## HISTORIC DISTRICT COMMISSION

## MEMORANDUM

**RE:** Historic District Permit Application: 727 Butler Street

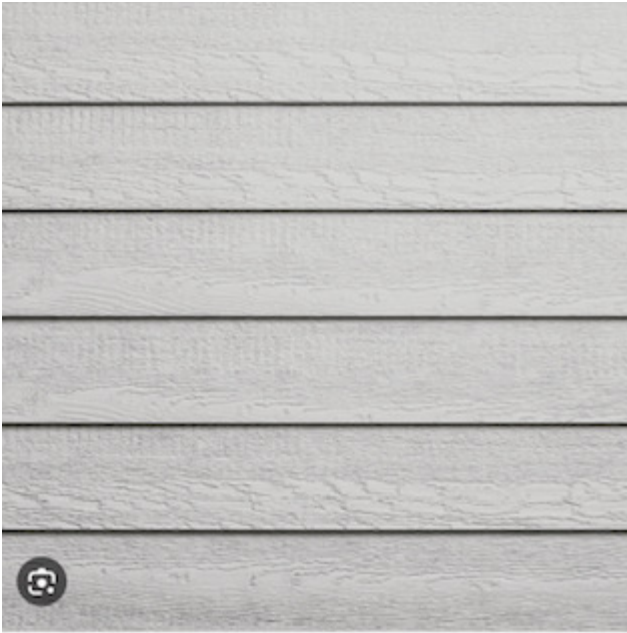
**Comment:** A smooth style of engineered wood is proposed for the replacement siding (horizontal).

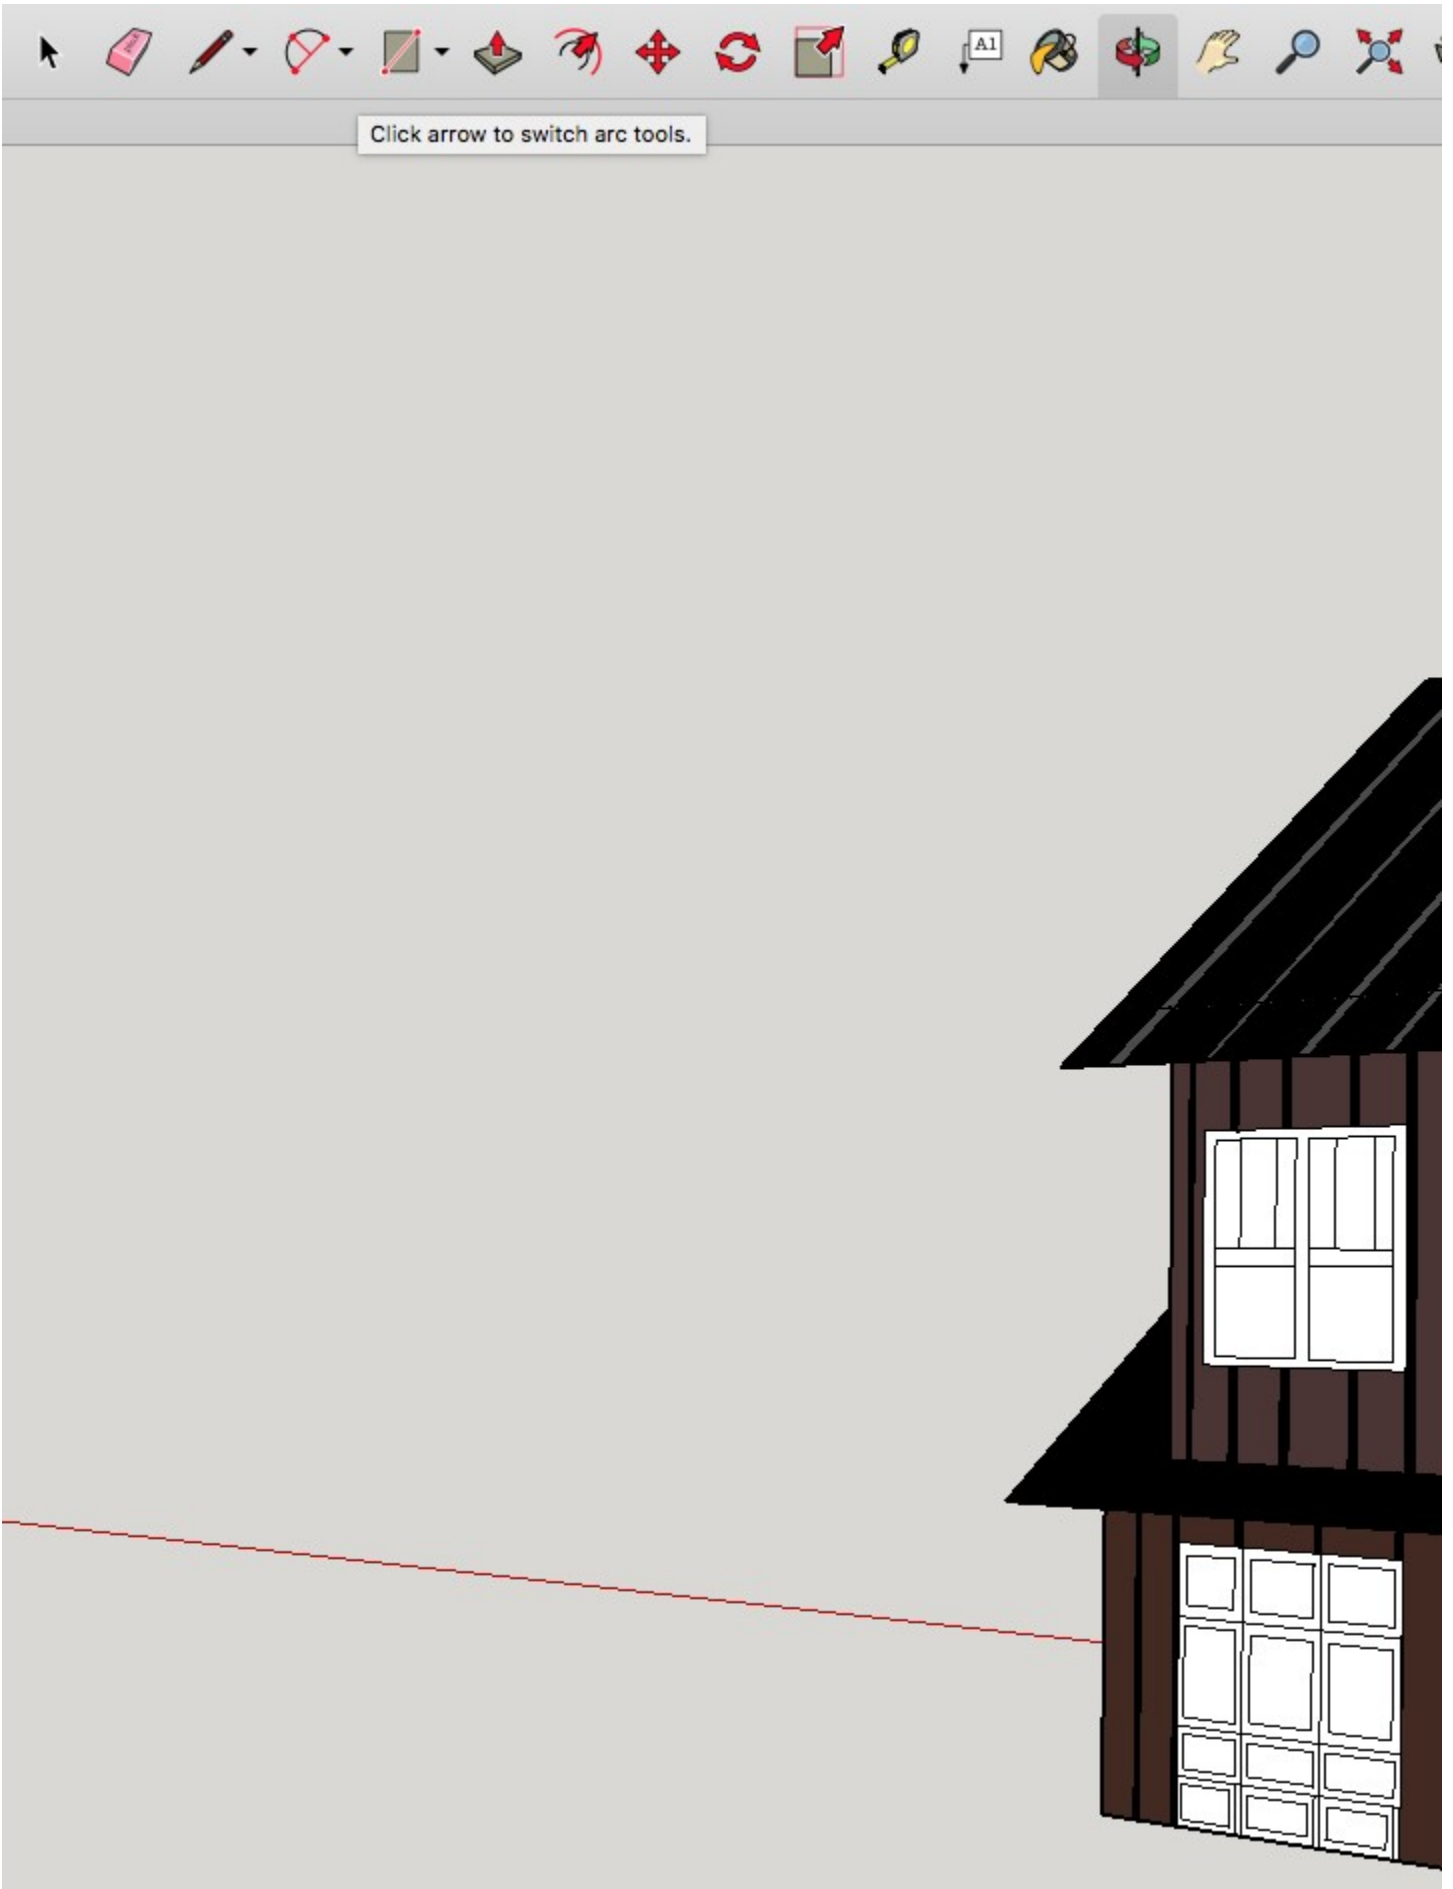
**Comment:** The remodeled and expanded building includes a gable roof, while the roof of the dwelling is hipped (the current garage has a gable roof). The proposed metal roof will match the new metal roof on the principal dwelling.

The siding is proposed as textured wood, which differs from the smooth engineered wood siding proposed for the principal dwelling. It appears that a vertical board and batten siding style is proposed for the front of the structure, but no specifications were provided. Further, the color of both buildings was not specified.

The HDC must also determine if the massing and scale are consistent with the character of the neighborhood.
